CNRO-2013-00008

SUBJECT: Application for Order Approving Transfers of Licenses and Conforming
License and ESP Amendments

Grand Gulf Nuclear Station, ESP, and ISFSI
Docket Nos. 50-416, 52-009, and 72-50

Marked-Up GGNS Facility Operating License Pages

(11) Environmental Qualification (Section 4.2.3.14, SER, SSER #2; SSER #5) System Energy Resources, LLC Appendix H,

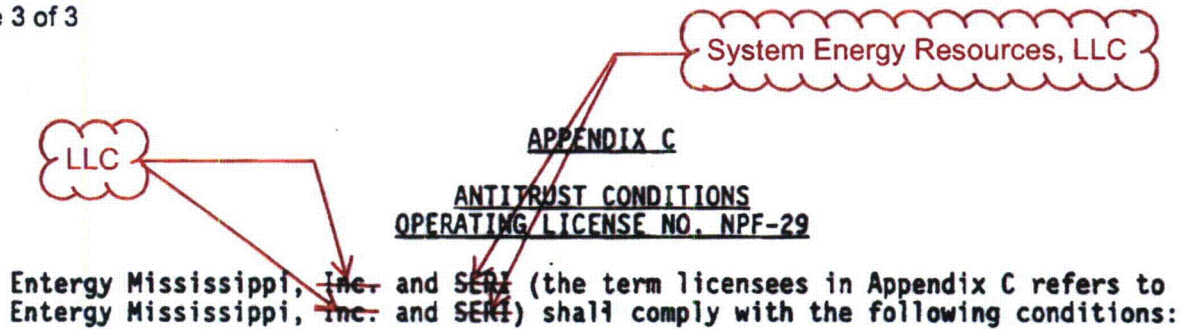
Entergy has determined that several pages of the GGNS Facility Operating License, which was affected by the request, were inadvertently omitted from the request. Marked-up pages reflecting the requested changes are provided in Attachment 1 with clean pages incorporating the changes provided in Attachment 2.

(11) Environmental Qualification (Section 3.11, SER; SSER #1; Appendix H, SSER #2; SSER #5)

Within 30 days after plant startup following the first refueling outage, System Energy Resources, LLC shall comply with items 1, 2 and 3 of Bulletin No. 79-26 and submit a written response to NRC on item 3.
